WATER-RIGHT DOCKET

Shenandoah National Park

SWIFT RUN SUB-MAINTENCE AREA WATER SYSTEM

Subject: Final Report - Swift Run Maintenance Area, Shenandoah National Park, by L. E. Gardner II, Shenandoah

Final Report
Swift Run Maintenance Area
Shenandoah National Park

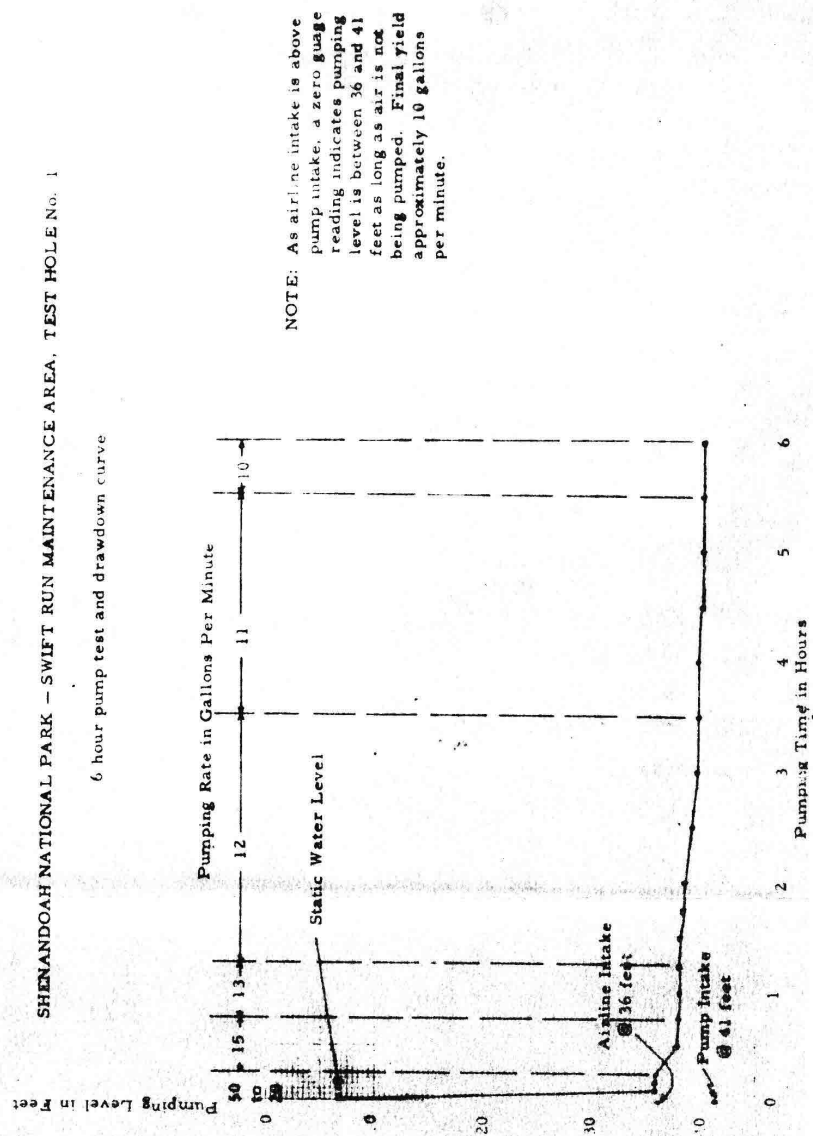
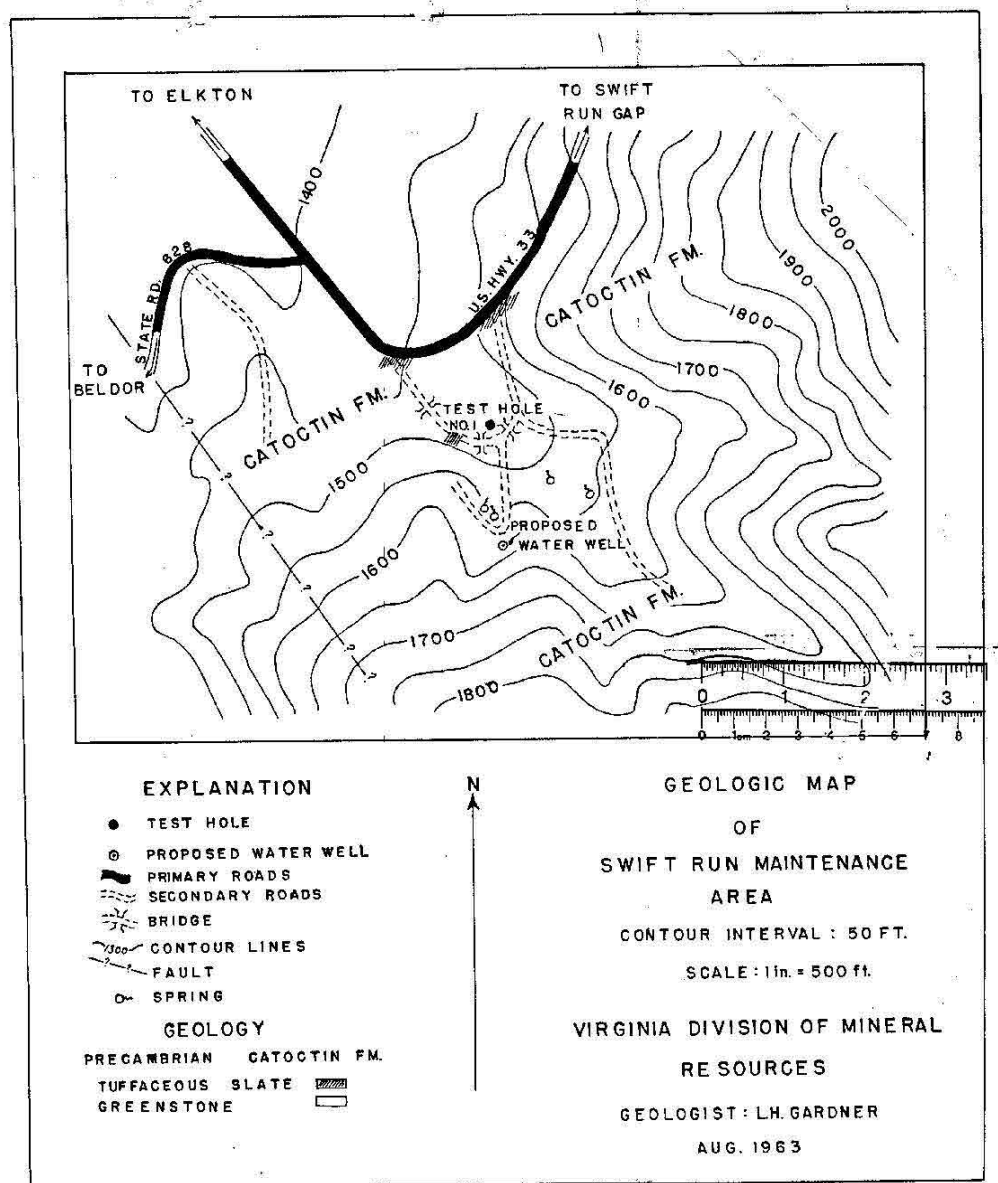
This rather brief report cannot be evaluated fully here because of lack of knowledge of specific conditions. Comparing this report with the preliminary report on the Swift Run Maintenance Area by E. R. Hopkins, it is noted that the test well was not drilled at the location recommended by Hopkins but some 600 feet farther north. The reason for this change should be given in the report. Further, the Gardner report now recommends a production well at the same location recommended as a test-hole site in the preliminary Hopkins report. Will the yield of the production well, in Mr. Gardner's opinion be sufficient to supply the maintenance area or should another test hole be drilled?

The estimated water need at the maintenance area is not given in the report but presumably the 10 gpm developed from the test well is insufficient. The test well, however, was drilled only 60 feet deep, whereas the report recommends that the production well be drilled to 150 feet. Would the yield of the test well be increased if it were deepened to 150 feet? Although the air-rotary rig could only drill to 60 feet, a standard cable-tool rig could deepen the hole to 150 feet without difficulty. The possibility of increasing the yield by deepening the test hole to 150 feet should be considered in the report.

Perhaps these points have been considered and discussed orally by personnel of this Service and the Virginia Division of Mineral Resources. Nevertheless, the reports are the only record of the test-well program and it is desirable that future reports be more comprehensive.

Headquarters Area: The preliminary report located three test well sites, and water resources funds were programmed for two wells. Test Well No. 1 was drilled at the location designated in the preliminary report. Test Site No. 2 could not be used because the Virginia Department of Highways plans to construct a four lane highway over the site. After drilling Test Well No. 1 and abandoning Site No. 2, the State Geologist recommended relocation of Site No. 3 because of additional geological data obtained from the first test well. They selected a site in the Loudoun formation approximately 120 feet northwest of the intersection of the entrance road to the Headquarters Area and U. S. Highway 211 (this site is shown as a proposed water well on the final report). Because of the inaccessibility of this site and the damage which would result from the construction of an access road, this site was rejected by the Park staff after consultation with Key Regional personnel. An alternate site was selected back of the maintenance area near the site where a hand dug production well once existed. This test well proved to be a very good producer (23 gallons per minute). A permanent pump has been installed in the well and arrangements are being made to reimburse the water resources account for drilling this production well. Since this well will furnish all water needed in the Headquarters Area for many years, no further drilling is proposed for the area. Bacteriological samples are taken from the production well twice each month, and no contamination has been found.

Swift Run Maintenance Area: The preliminary report recommended one 150-foot test well and funds were programmed on this basis. Before the drilling operation was started, further geological study by Mr. Gardner revealed that the location of the proposed well should be approximately 800 feet from the site selected by Dr. Hopkins. The well was drilled at this revised location and at a depth of approximately 60 feet the strata became too soft and porous for the modern air rotary drill rig to operate. Since the well is ideally located and is capable of producing 12 gallons per minute, Park officials agreed to accept the well. This 12-gallon per minute supply is adequate for the small maintenance area and three employee residences proposed for the area and additional drilling is not proposed. The savings resulting from the acceptance of this shallow well greatly reduced the amount of additional funds required to finance an urgently needed well at Thornton Gap under Change Order No. 1

We will ask the State Geologist to include more details in their final reports on future test well drilling and pump testing operations, but we do not believe a special meeting is needed at this time.
